June 27, 2025

**Re: Chapter 105 Joint Permit Applications – Response to Technical Deficiency Notification  
Tioga Pathway Project  
DEP Application No. E5983220-013 (Tioga Co.), APS ID No. 1125745; AUTH ID No. 1506547  
DEP Application No. E5383224-006 (Potter Co.), APS ID No. 1125735; AUTH ID No. 1506536  
Tioga and Potter Counties, Pennsylvania**

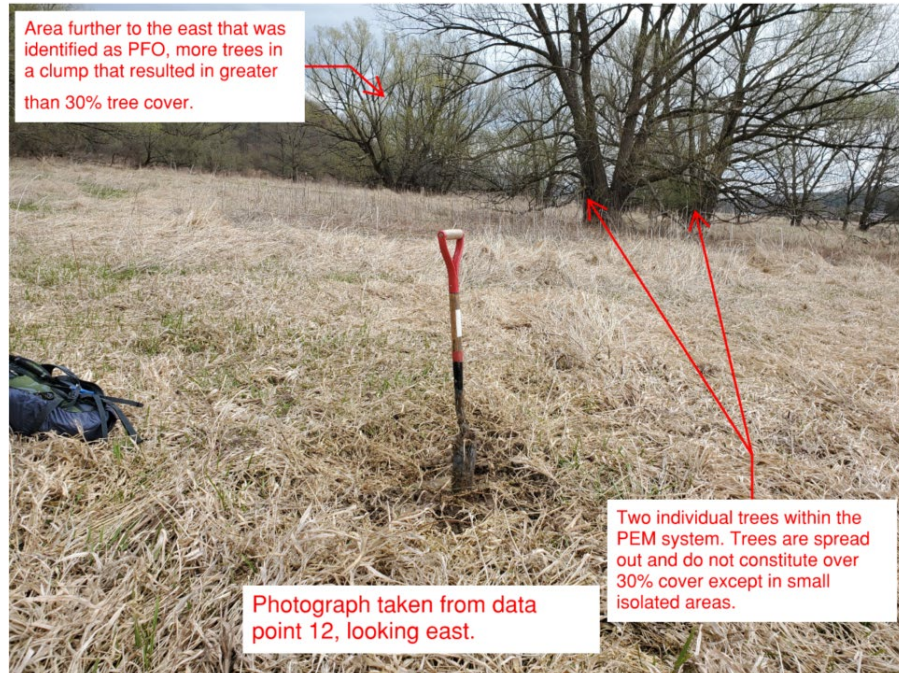
37. *From the aerial images in the PRM Plan it appears that existing PEM and PFO habitat may be overestimated and underestimated, respectively. Please address. [25 Pa. Code § 105.21(a)(1) and 105.20a(b)]*

**Response:** While aerial imagery can be useful for an informal site examination, determining the Cowardin classification includes factors (plant cover, type, soil composition, etc.) that can only be ascertained on site during the field delineation. The RES ecologists who performed the wetland delineation were consulted and indicated that the dominant cover type within the area identified as PEM are herbaceous, except for two individual trees. The wetlands in this location do not function as forested wetlands identified elsewhere on-site. An annotated photograph has been included below to further support the findings.
